21/04122/CONDT1 | Details submitted to discharge conditions in relation to planning ref 21/04122/FULL1 (Allowed at appeal ref: APP/G5180/W/22/3296844): Condition 5 - Slab Levels Condition 6 - Materials Condition 7 - Cycle and Refuse Condition 10 - Electrical Charging Point Condition 14 - Landscaping | 2 Bromley Avenue Bromley BR1 4BQ

We **object** to this application.

Plans show space for only 10 cycles

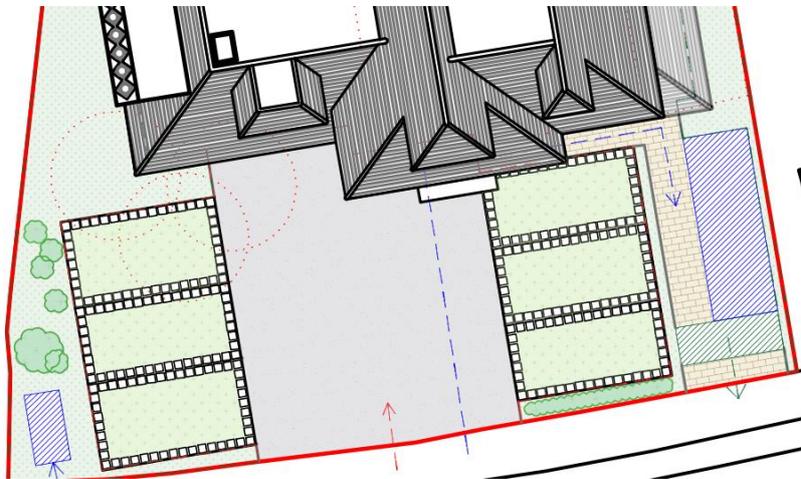
The Appeal decision (below) requires 14 cycle spaces to be provided. The plans show only 10. There is no visitor cycle parking either.

We note that the original plans showed cycle parking to the right of the property. However, the space shown (in blue) is not big enough to accommodate 3 (required for 15 spaces) of the proposed cycle shelters:-

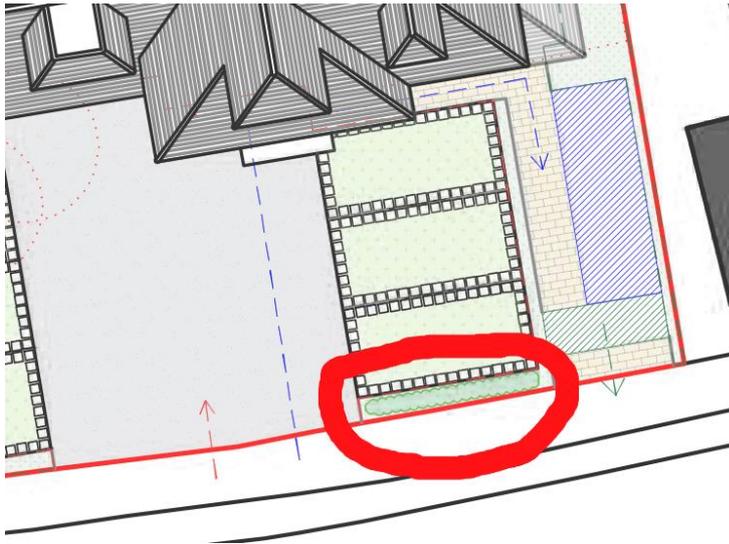
The layout of the car park has changed significantly from the approved plan 0534-DE-202. Approval was given for the following plans: -

The car park is now much more cramped. The distance between opposite spaces is significantly reduced which will make manoeuvring difficult. Cars are likely to reverse out of the car park affecting the visibility splay (Condition 9 applies) and pedestrian safety. No wheel tracking has been provided.
